RE: **Memorial Park Anderson Heights Unit 4**
Engineer's Stamp Date: 12/18/2017
Hydrology File: N08D006F1

Based on the information provided in the submittal received on 12/19/2017 the above-referenced Grading and Drainage Plan cannot be approved for Grading Permit or for Building Permit until the following comments are addressed.

MEMORIAL PARK
OVERALL GRADING & DRAINAGE PLAN

POND CALCULATIONS AND DETAILS

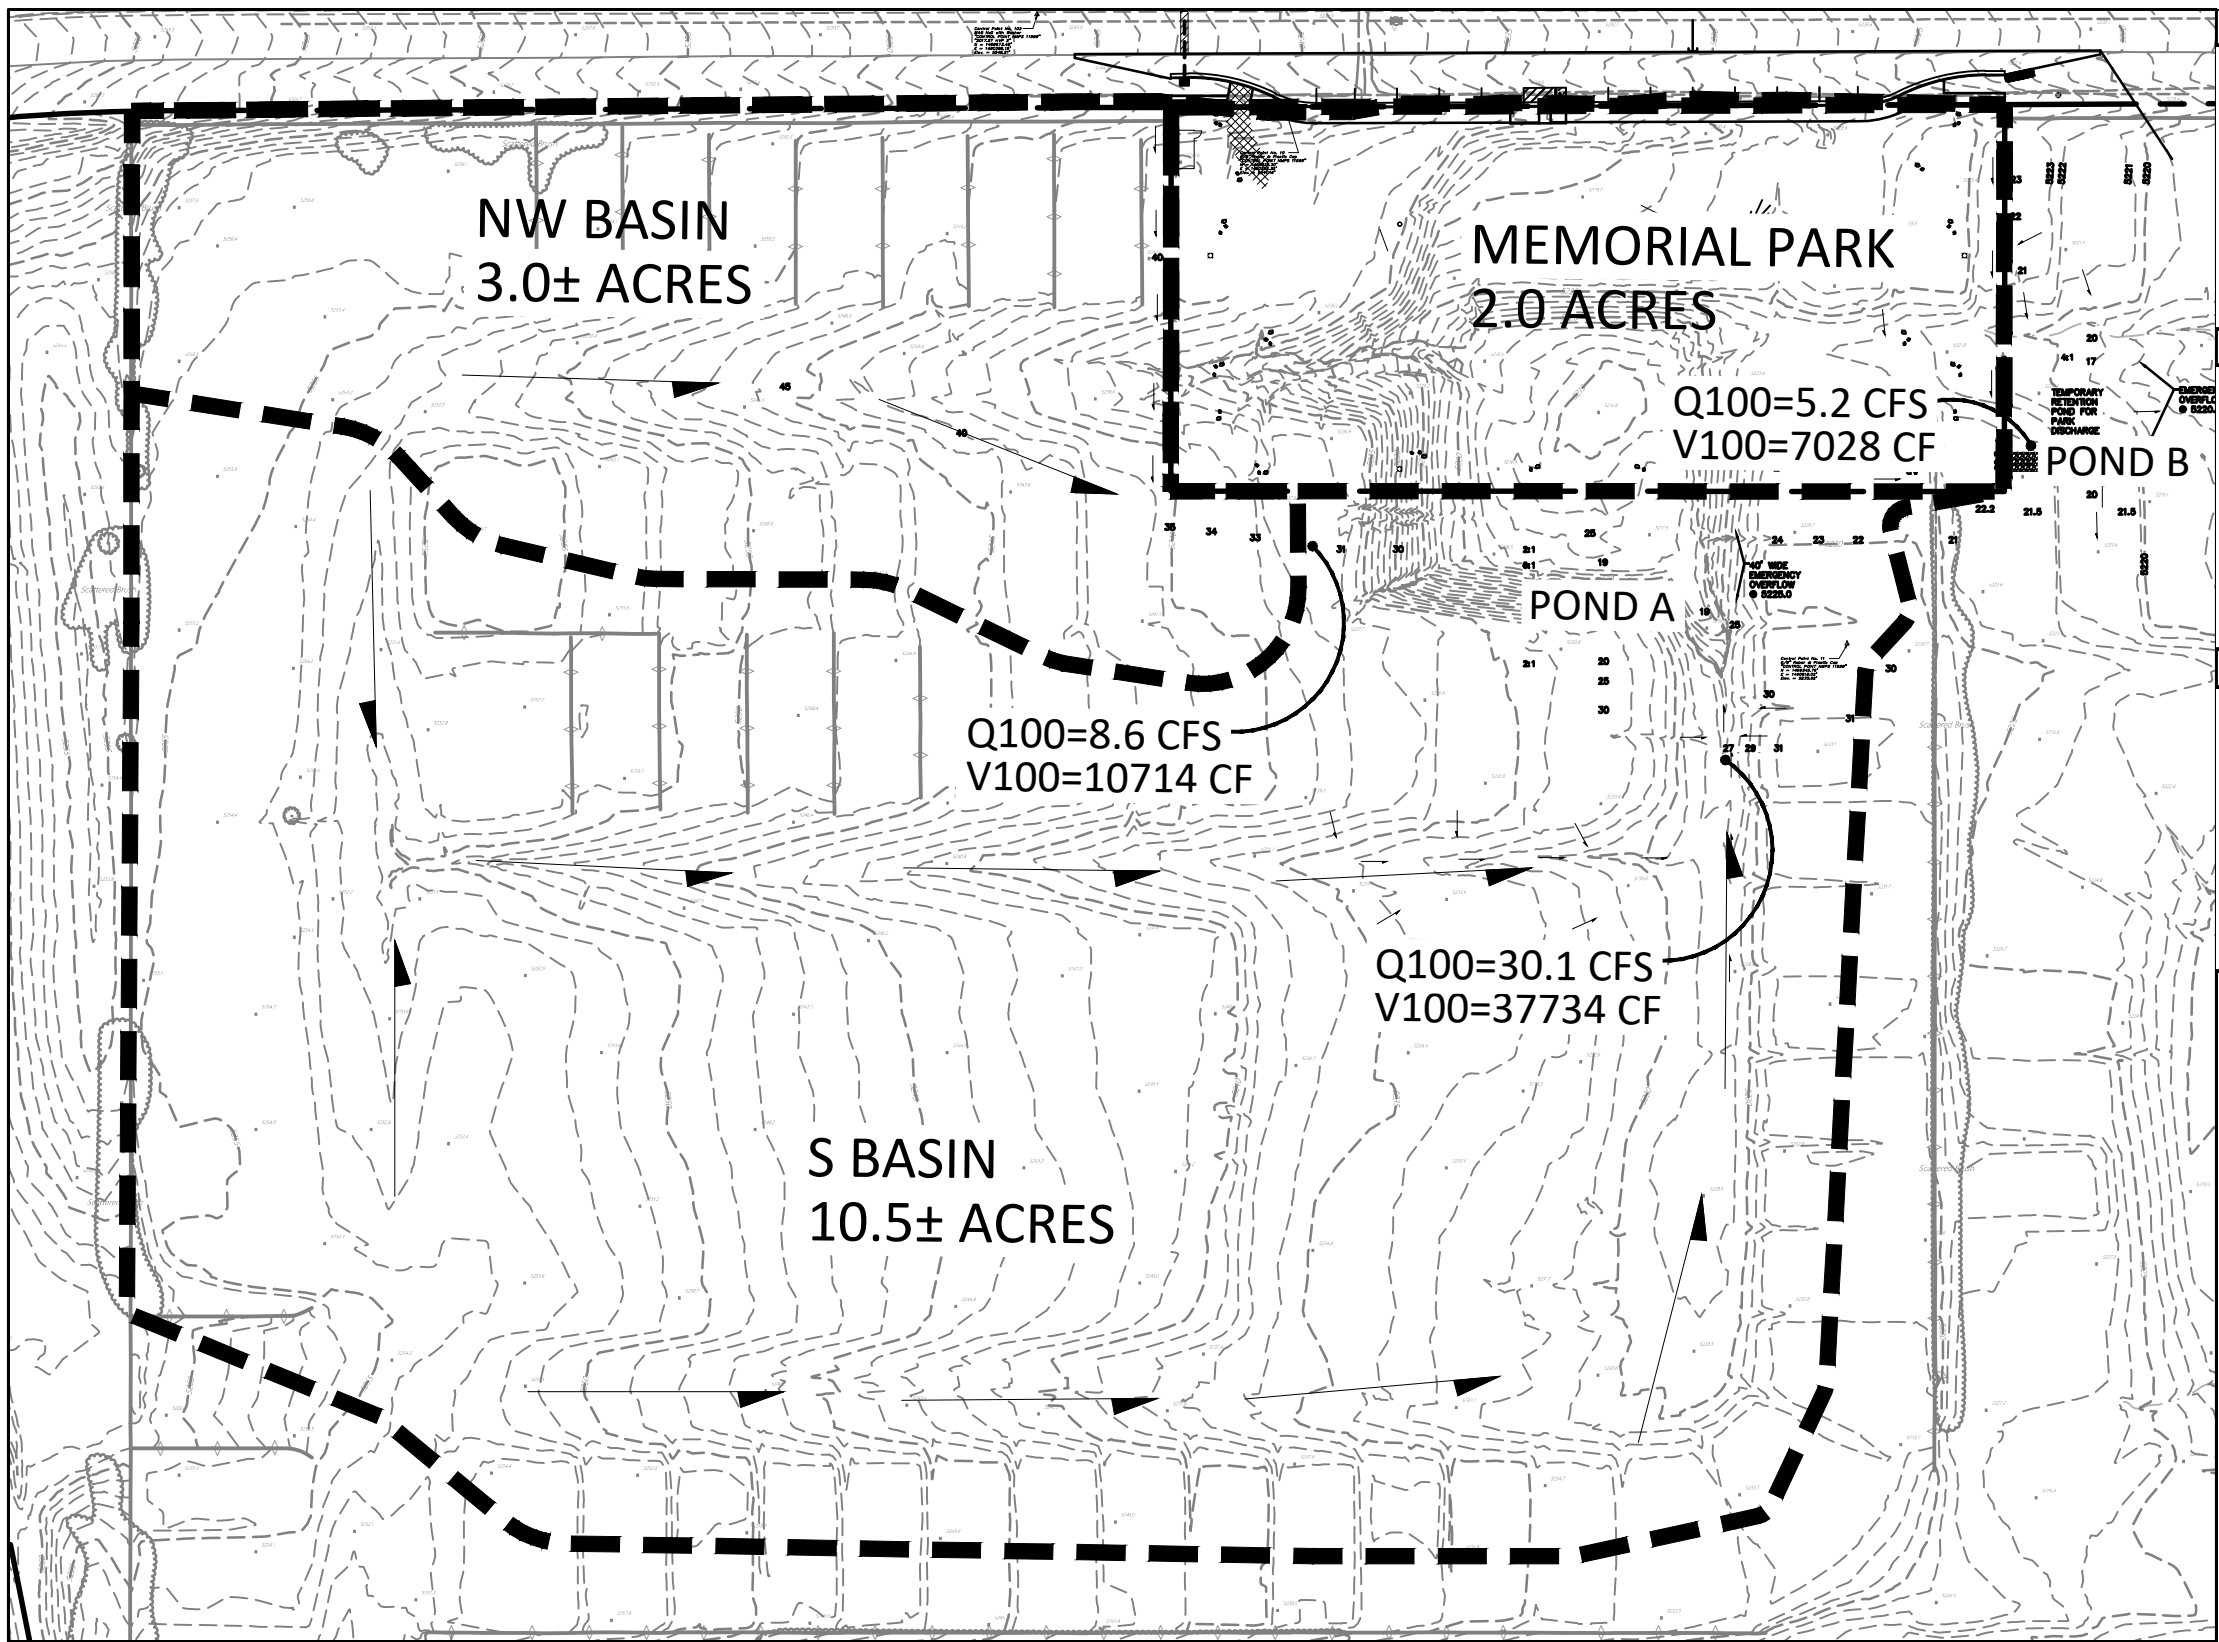
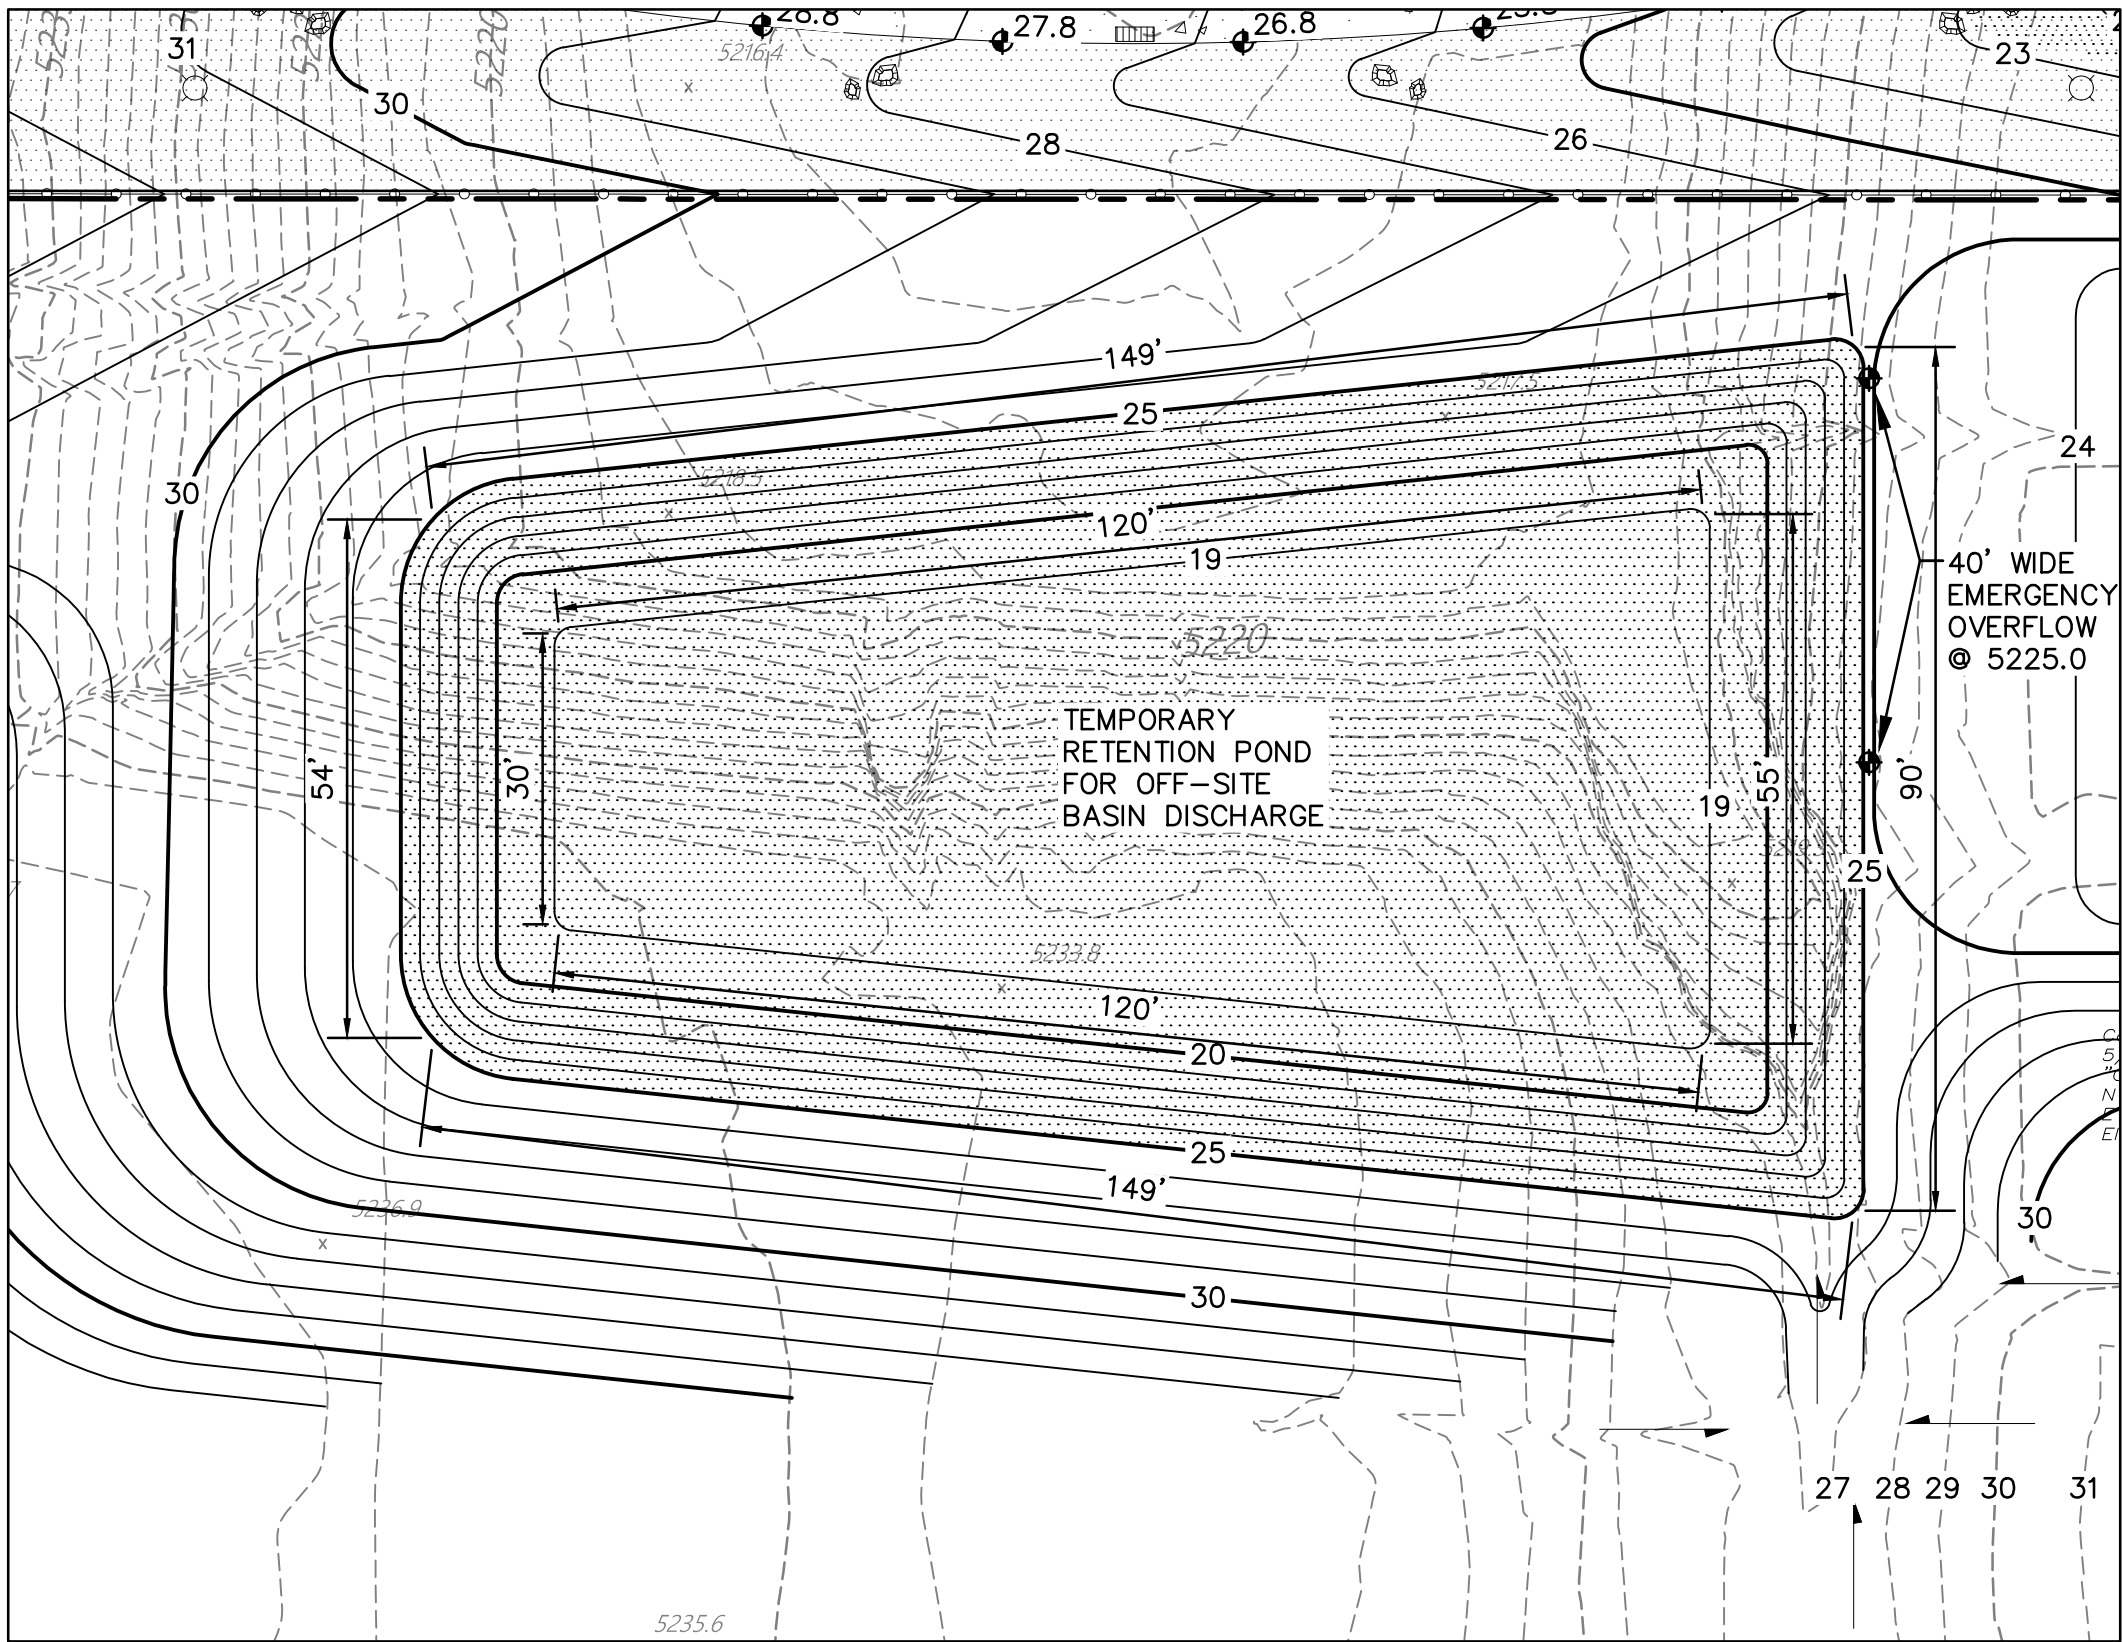
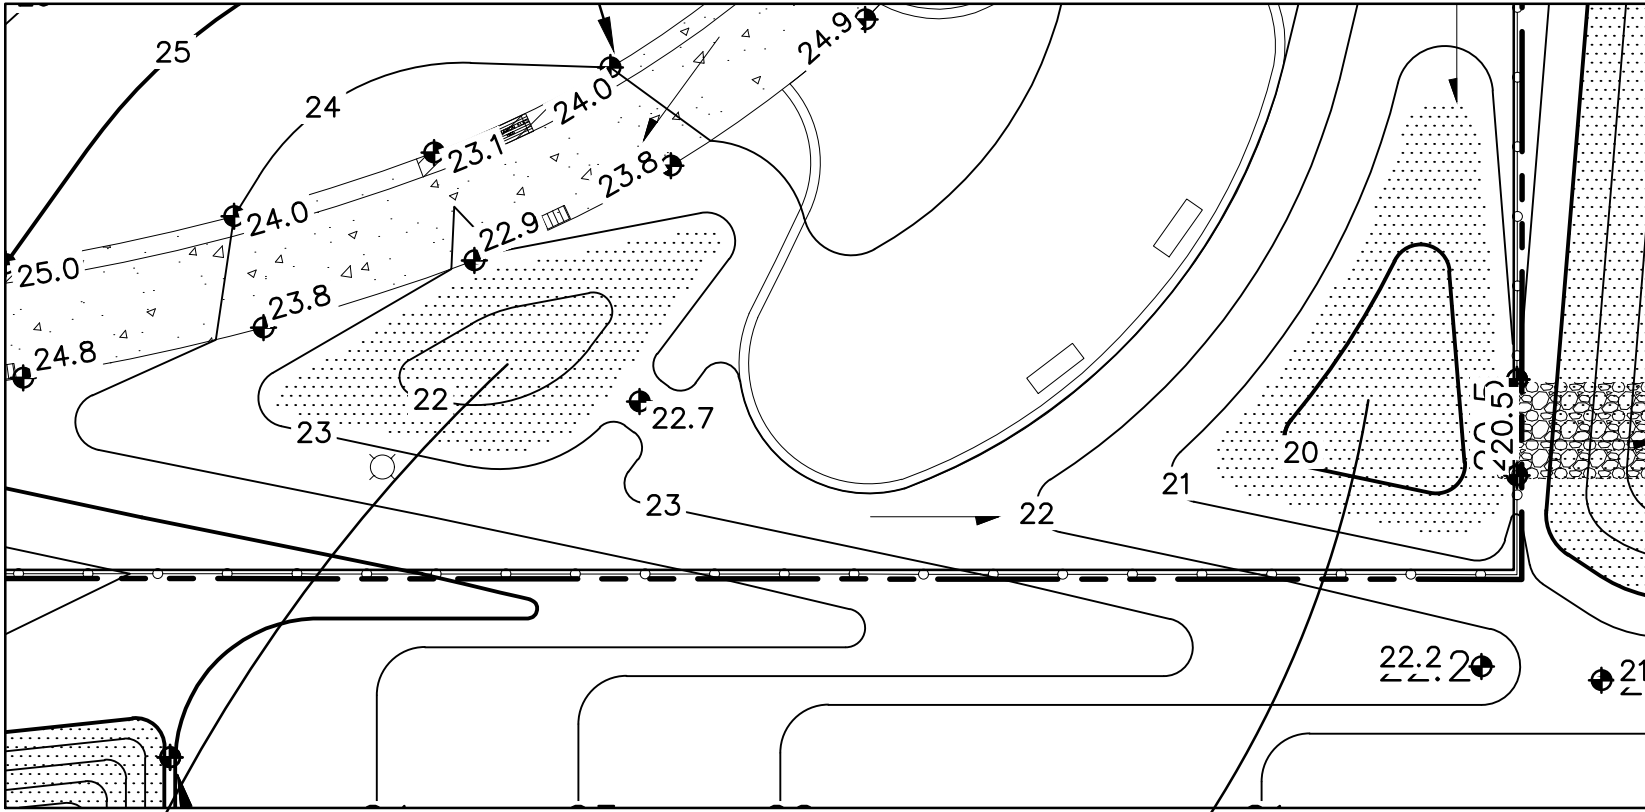
1. A Public Drainage Easement must be recorded to contain the east temporary retention pond.
2. A new Drainage Covenant must be recorded for the new pond location. The previous covenant can be released if the new covenant includes all of the ponds shown on the previous covenant.
3. Provide a letter of permission from the owner of the neighboring property for the grading on their property.
